## Planning Commission Staff Report

**Meeting Date:** June 26, 2017

**From:** Jessica Henry, Senior Planner

**Petition:** **P.Z. 03-2017 Fienup Farms (McBride & Sons)**: A request for a zoning map amendment from an “E-1” Estate One-Acre District to a “PUD” Planned Unit Development for 223.02 acres located on the north side of Wild Horse Creek Road approximately 3,250 feet east of its intersection with Kehrs Mill Road and 4,400 feet west of its intersection with Baxter Road (18U640049, 18U630028, 18U330454, 17U310093, 17U320070, & 17T110201).

Job Number: 14-06-196  
 Date: 6/16/2017  
 Designed: MF Sheet  
 Drawn: SL 2.1  
 Checked: PRE

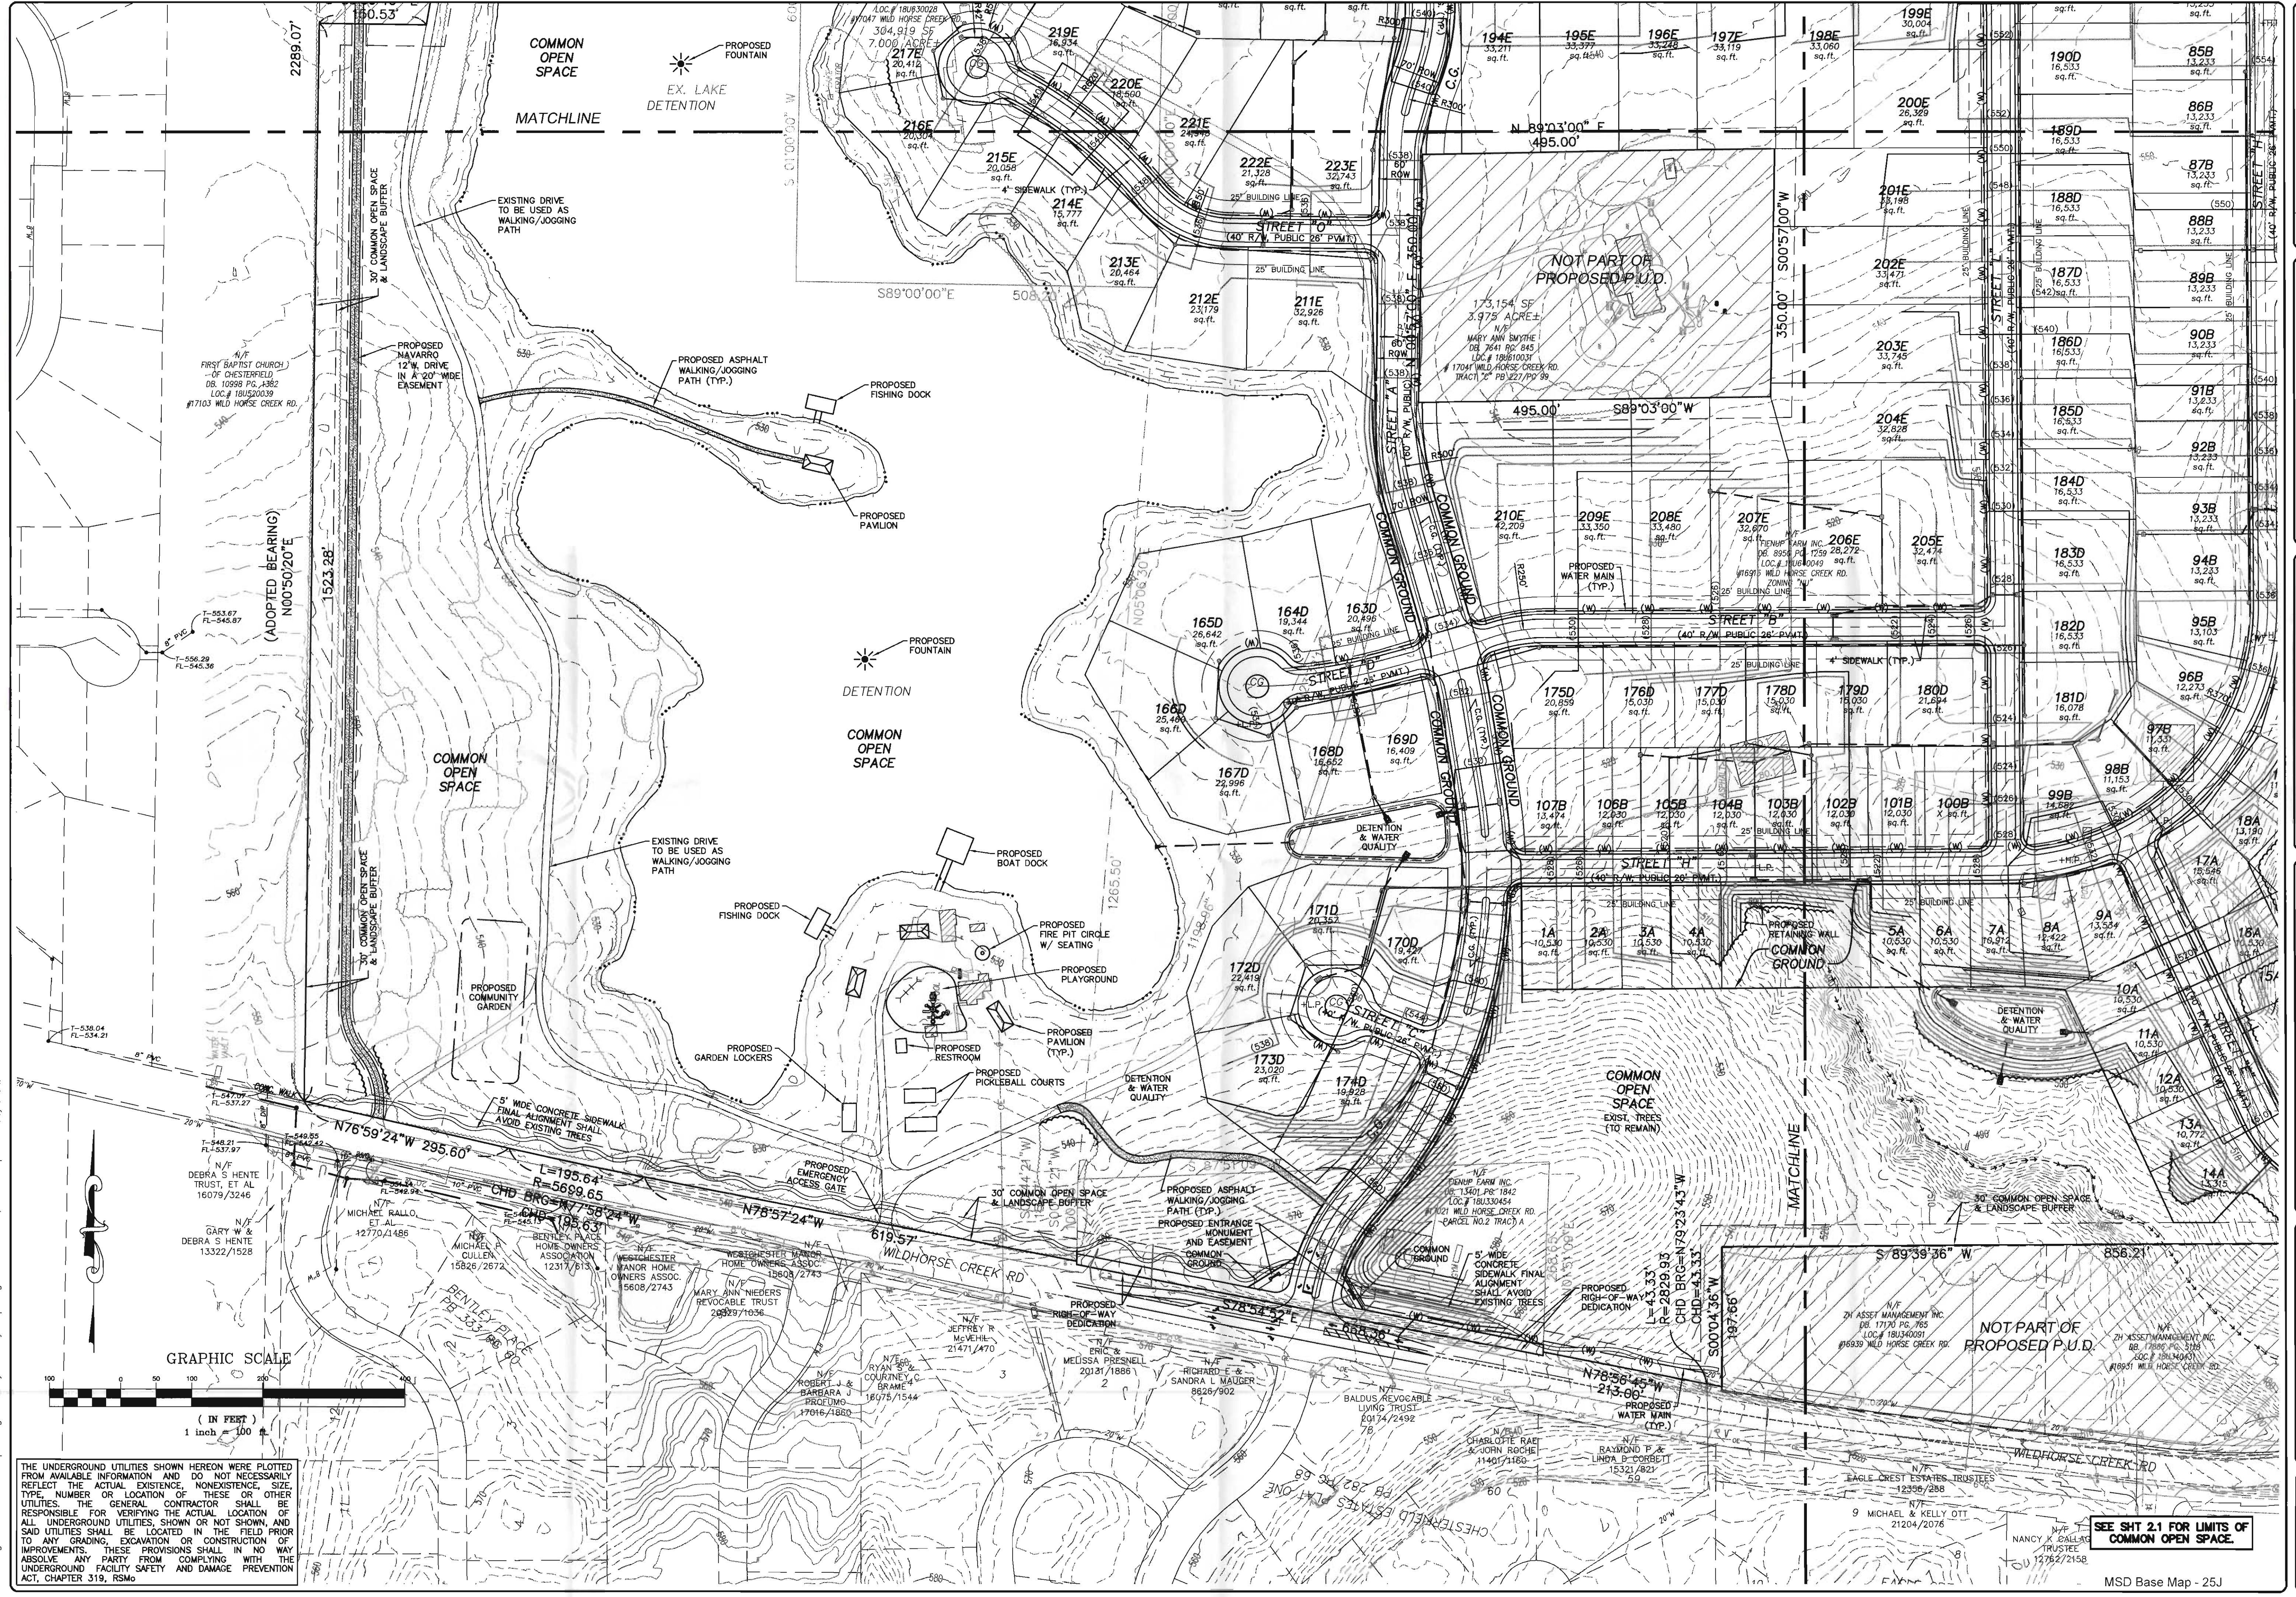
SEE SHT 2.1 FOR LIMITS OF COMMON OPEN SPACES.
